DEVELOPMENT ASSESSMENT REPORT

Application No.	D/2019/381
Address	194 Short Street, Birchgrove
Proposal	Alterations and additions to existing dwelling-house, including to provide a roof terrace and associated access.
Date of Lodgement	27-Sep-2019
Applicant	J Scuteri
Owner	Delatex Pty Ltd Fodero Enterprises Pty Ltd
Number of Submissions	Objections from 8 properties.
Value of works	\$85,000
Reason for determination at Planning Panel	Variation exceeds officer delegation (FSR)
Main Issues	View Loss, Privacy impacts, Impacts to Streetscape and Heritage Conservation Area, Variation to FSR.
Recommendation	Refusal
Attachment A	Draft Conditions if application is approved
Attachment B	Plans of proposed development
Attachment C	Statement of Significance

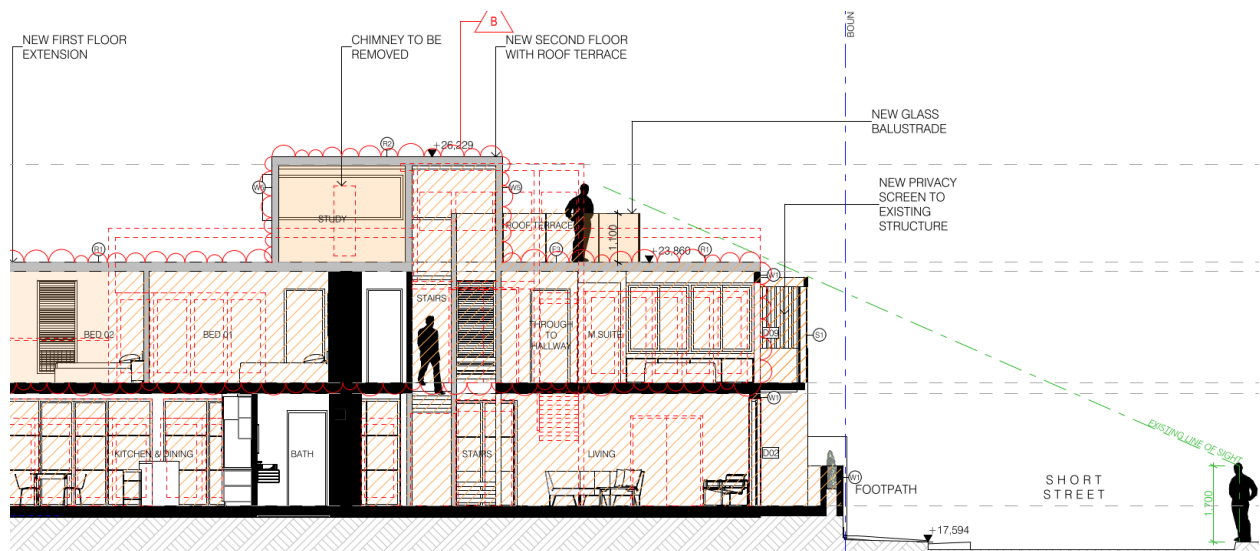
The roof terrace at 190 Short Street was approved under D/2018/504 and it is noted that the roof terrace is located on the second floor (as opposed to the third floor roof terrace proposed in this application) with the maximum height of the associated structures being RL26.229 (see figure below), which is lower than the existing maximum height at 194 Short Street (RL27.31) and significantly (3.5m) lower than the proposed maximum height of the works proposed in this application (RL29.77).
